REVISED HERITAGE IMPACT ASSESSMENT & CONSERVATION PLAN FOR 211-231 BANK

Applications D02-02-22-0127 / D07-12-22-0188 and plan number 18910

Revision 2: October 2024

The following conservation plan is an update of the HERITAGE IMPACT STATEMENT submitted June 2023, Applications D02-02-22-0127 / D07-12-22-0188 and plan number 18910. It responds to comments provided by the City of Ottawa. The comments are listed below:

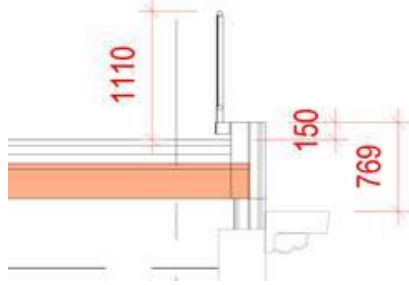
Heritage Application 219-223 Bank Street, at 178 Nepean Thank you for your submission, heritage staff are pleased to see the response to our comments and the detailed engineering study of each façade. Comments regarding the design:

Response:

The upper floors were intended to provide background vanilla and help focus on the podium and pedestrian scale of Bank Street. The planned Richcraft highrise towers adjacent to the site will overwhelm the nine storey and the distinction will further emphasis the foreground.

This could be a red/brown or black accent colour that relates to the existing brick or cornice colour. This will help to integrate the new construction better to the Centretown HCD.

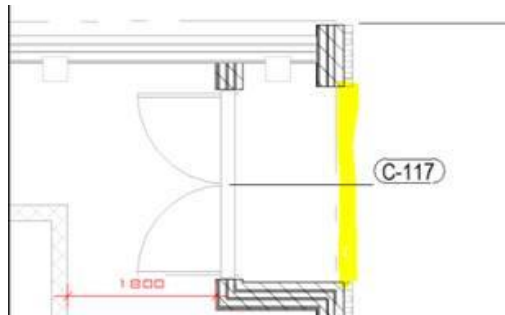
- Recess the Lisgar entrance to maintain the character of the carriageway. This feature was identified as a heritage attribute in the Conservation Plan and there are few left in the HCD, so should be respected.

Response:

The doors have been set back but with the need for security and these alcoves being used for sleeping, would a metal grid used at night be acceptable (yellow highlight below)?
